**TOWN OF LOS GATOS
COUNCIL MEETING AGENDA
NOVEMBER 15, 2022
110 EAST MAIN STREET AND TELECONFERENCE
TOWN COUNCIL CHAMBERS
LOS GATOS, CA
7:00 P.M.**

On November 5, 2019, the Town Council adopted Resolution 2019-053 (Exhibit 1 of Attachment 5) to authorize application for, and receipt of, SB 2 Planning Grant Program funds, including execution of an agreement with the California Department of Housing and Community Development (HCD) by the Town Manager. Planning staff submitted an application with a proposal to develop objective standards for the review of qualifying housing development applications. The Town received approval of the application and entered into an agreement with HCD to receive reimbursable grant funding for the proposed scope of work.

Figure A.3.1

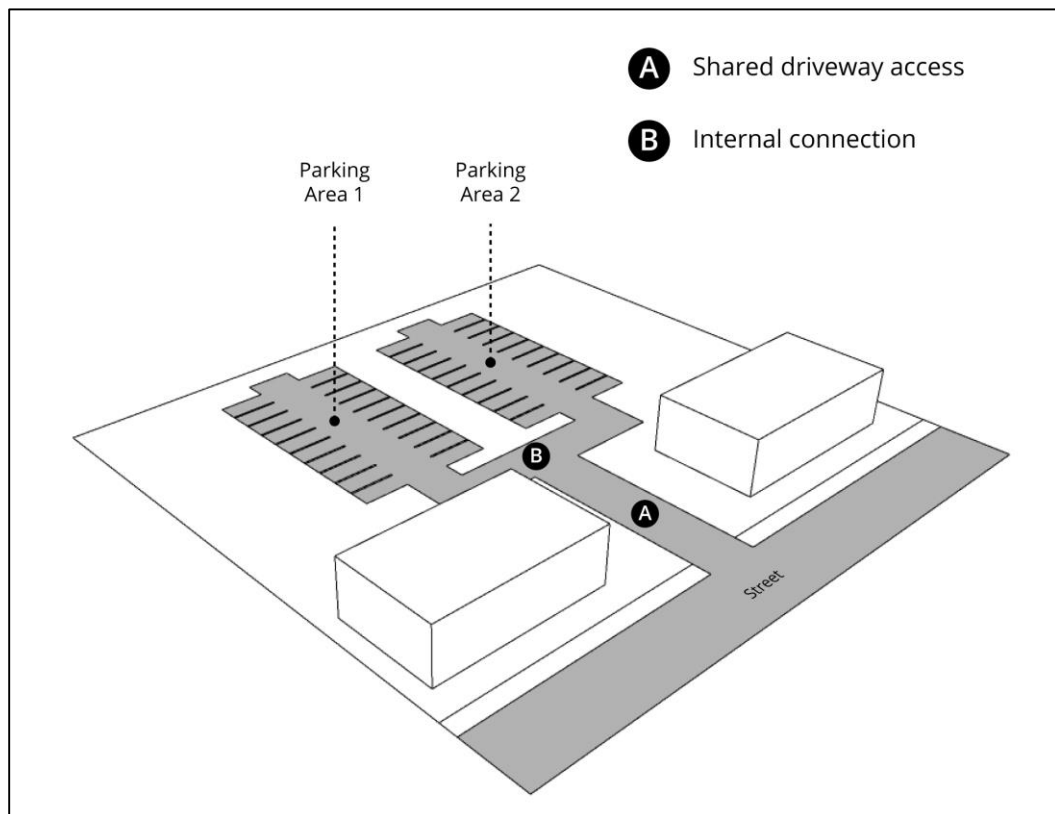
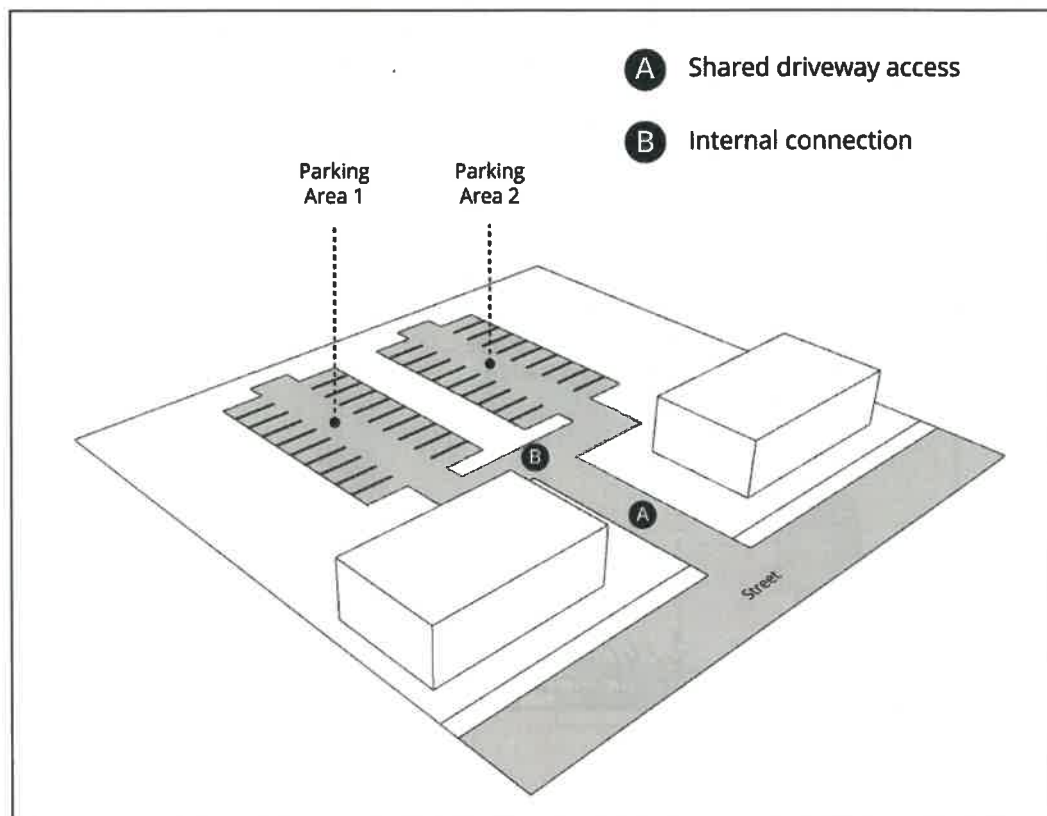
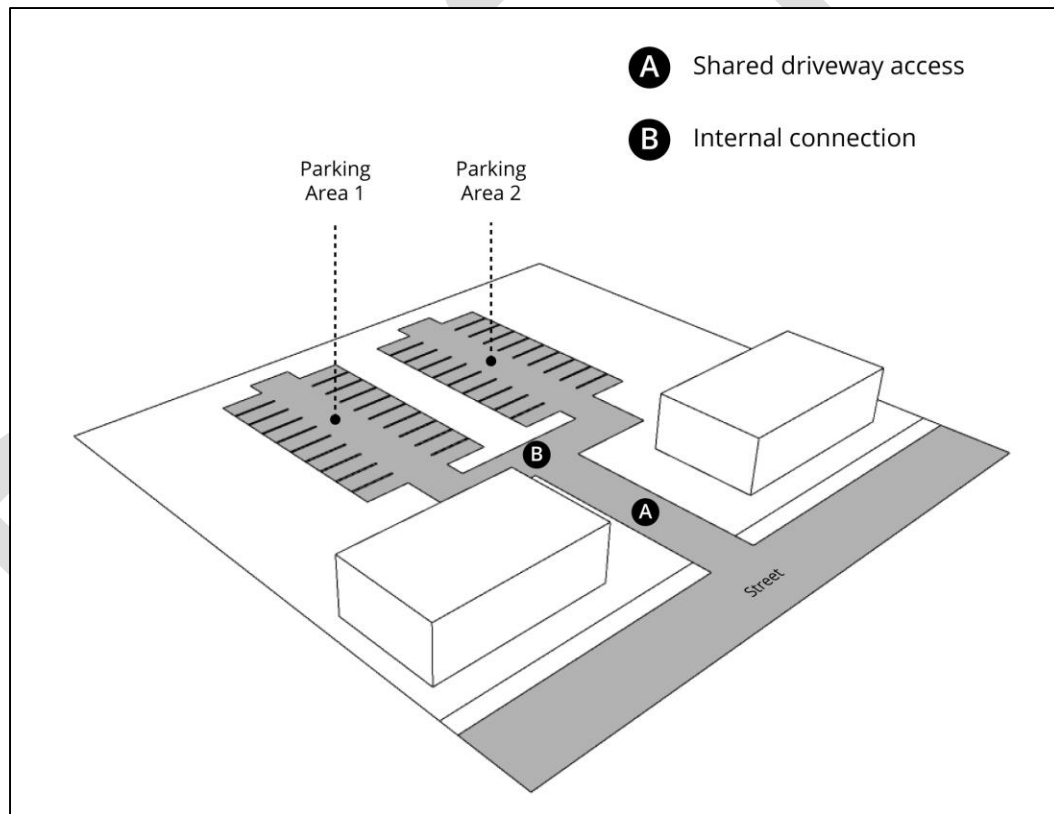
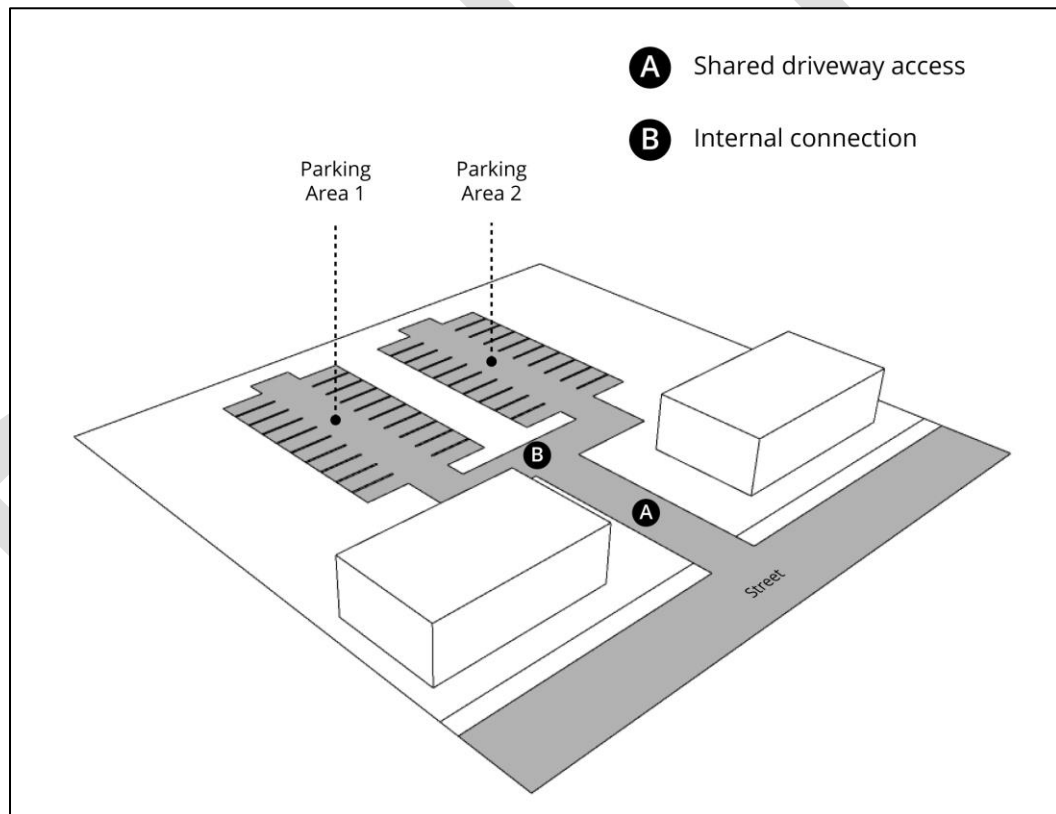
Figure A.3.1, A.3.1 and A4.3 need clarification

:What is the difference between aisle to aisle circulation (A3.1) and parking areas (Figure A3.1)? Does Figure A.3.1 represent multiple parking areas (see A.4.2) or aisle-to-aisle circulation of A.3.1.

Figure A.3.1, A.3.1 and A4.3 need clarification

What is the difference between aisle to aisle circulation (A3.1) and parking areas (Figure A3.1)? Does Figure A.3.1 represent multiple parking areas (see A.4.2) or aisle-to-aisle circulation of A.3.1.

Figure B.1.1b

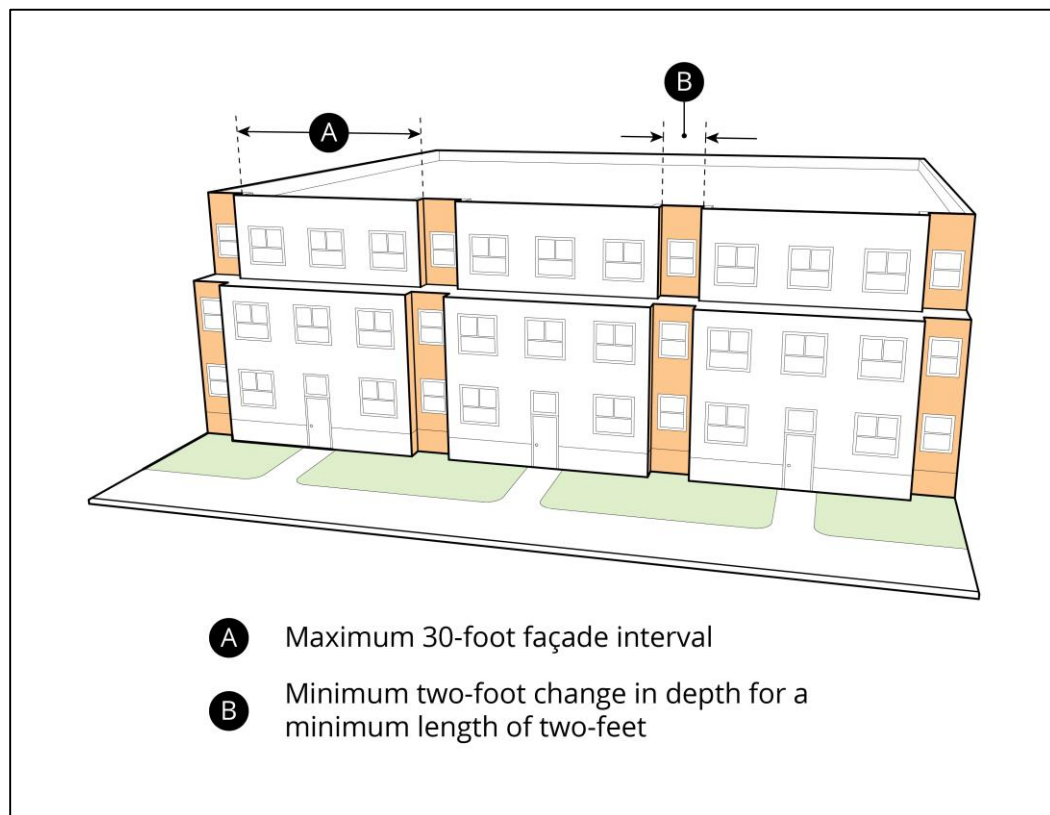
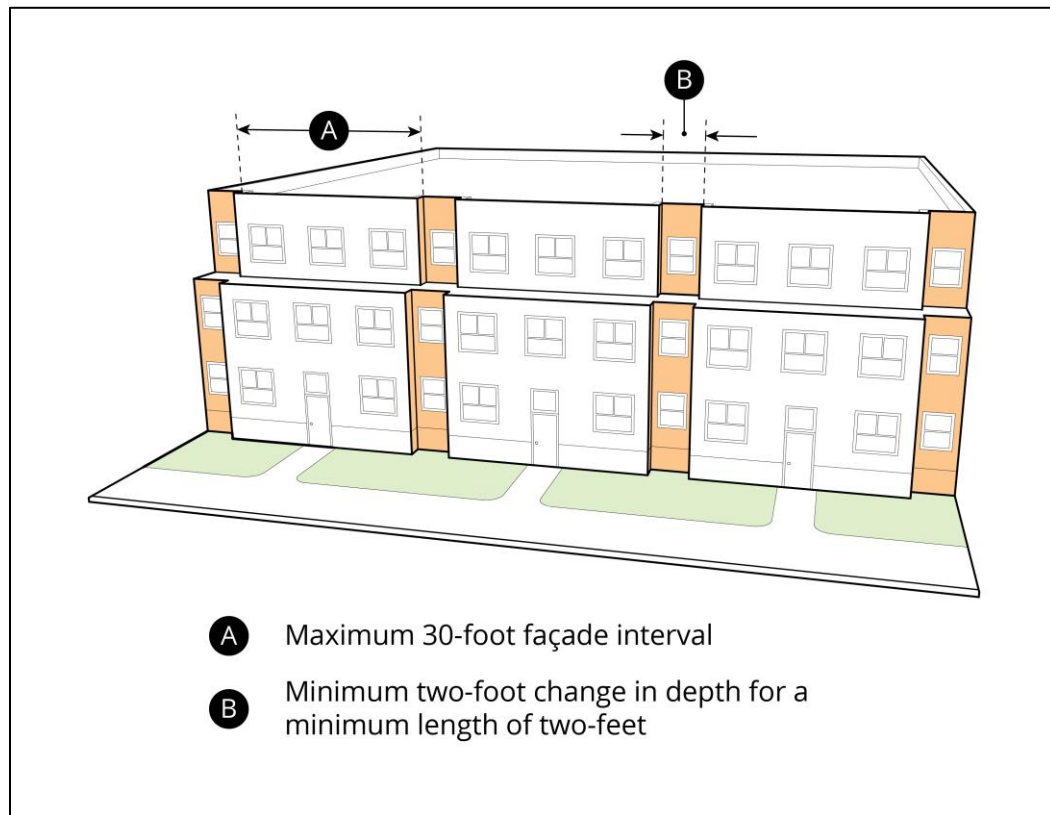
(5) Figure B.1.1(b) on Page 238: should this only apply to staircases that are open to view?

Figure A.11.1

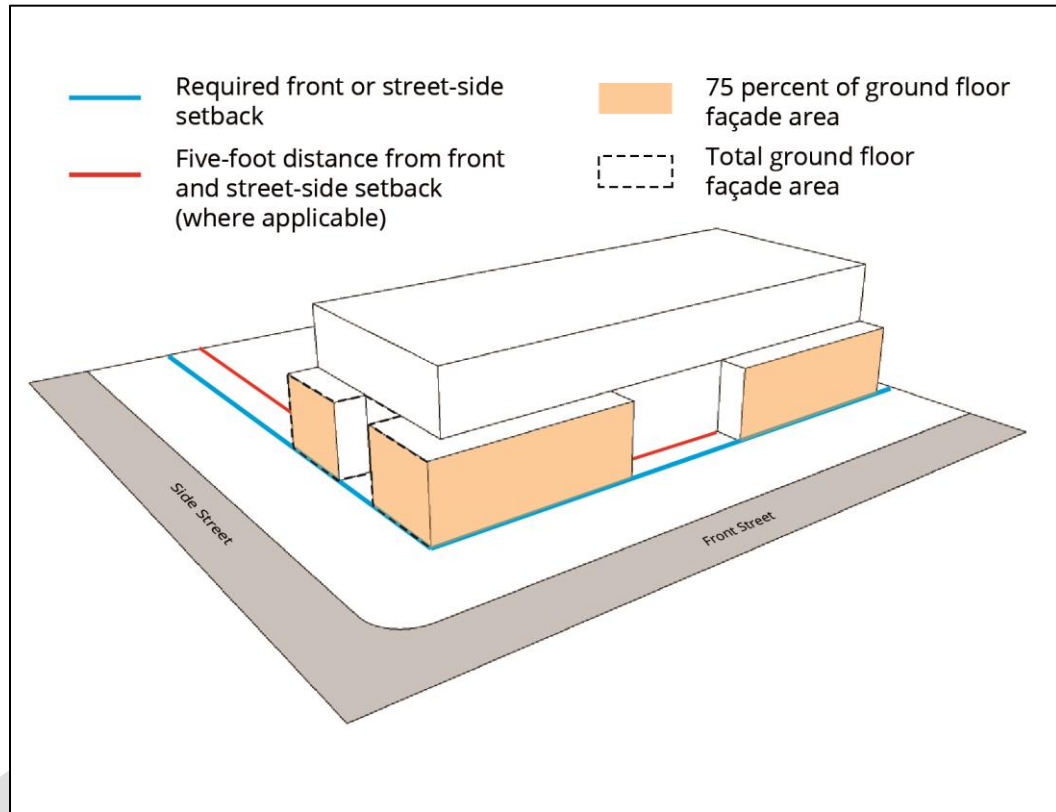
40	A.10.1	A.11.1	Staff addition/revision.	Changed "Community Place District" to "Community <u>Growth</u> District".
41	A.10.1	A.11.1	Why does this only include Community Growth Districts (CGDs)?	<p>The following polices discussing setbacks are included in the Community Design Element of the 2040 General Plan:</p> <p>CD-2.10 (Town-wide): Well-Defined Street Fronts - Require new buildings to maintain a consistent setback from the public right-of-way in order to create a well-defined streetscape. Require new buildings throughout Town to use consistent setbacks.</p> <p>CD-7.1 (All CGDs): Neighborhood-Friendly Design - Encourage buildings and sites within all Community Growth Districts regardless of designation, including shopping centers undergoing redevelopment, to integrate design features that create a pedestrian- and neighborhood-friendly environment, such as by siting buildings close to the sidewalks, providing space for small plazas, and including public art.</p> <p>CD-9.1: (LGB CGD): Setbacks and Step Backs of Massing - Require medium density, high density, and mixed-use parcels in the Los Gatos Boulevard District adjacent to single-family parcels to include increased site setbacks and multi-story step backs to minimize the impact and increase compatibility with smaller adjacent structures.</p> <p>CDP-11.7: (Lark CGD): Reduced Setbacks - Allow reduced setbacks to foster a more urban environment focused on corporate centers, commercial shopping areas, medical services, and hospitality uses.</p> <p>Consistent setbacks are encouraged by CD-2.10, while reduced setbacks are encouraged in CGDs. For this reason, Standard A.11.1 was written specific to CGDs. Given the above polices and the comments made by the Commission during discussion of this item, staff requests direction on whether this standard should apply Town-wide or only within CGDs. The corresponding figure/diagram will be updated accordingly.</p>

- *This draft standard is currently worded to apply only to proposed buildings. The requirement applies to the buildings, not the street frontage. This does not mean that 75 percent of the street frontage needs buildings along the front; instead, it means that 75 percent of the area of the primary building(s) proposed must be on the street frontage (see Figure A.11.1).*
